The hill track at Cairngorm – a test case for the National Park (2)

The Officers Report for the Cairngorms National Park Planning Authority meeting on Friday which will consider the hill track at Cairngorm is as interesting for what it leaves out as for what it includes. This is over and above the policy omissions and enforcement failures considered in yesterday's post.

Landscape plan
Drg 4
Scale 1:1000
Printed at 100%

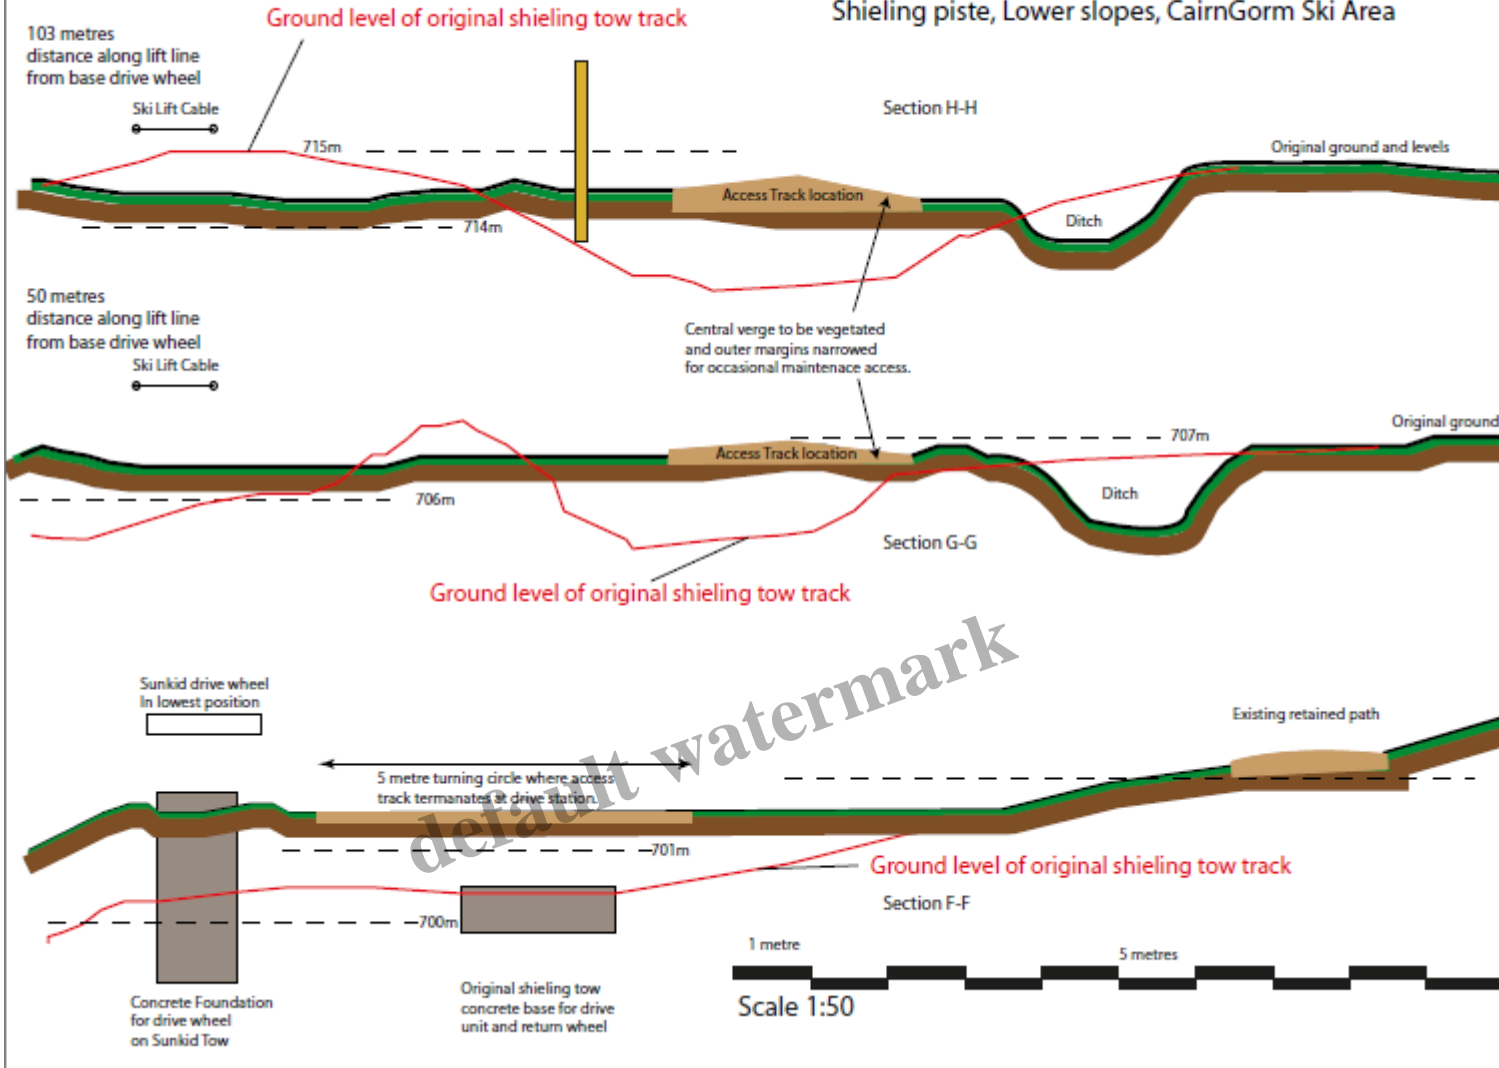
The brown areas are previous plantings, the green is additional planting proposed for 2017-18

The planting will not just hide some of the infrastructure, it should also – though there is no mention of this in the Report – compensate for some of the increased water run-off that has been created by the development. There are some other positive things in the plan, including works around both ends of the ski tow to improve landscaping; the work at the bottom will be done by hand. All of this is good. It should however have all been included in the original planning application, which was sketchy at the very least. Its clear to me that the public pressure has helped (or is it pushed) CNPA staff to take more interest in the development. A lesson here for the CNPA. Well thought out plans properly enforced would avoid lots of problems and public criticism.
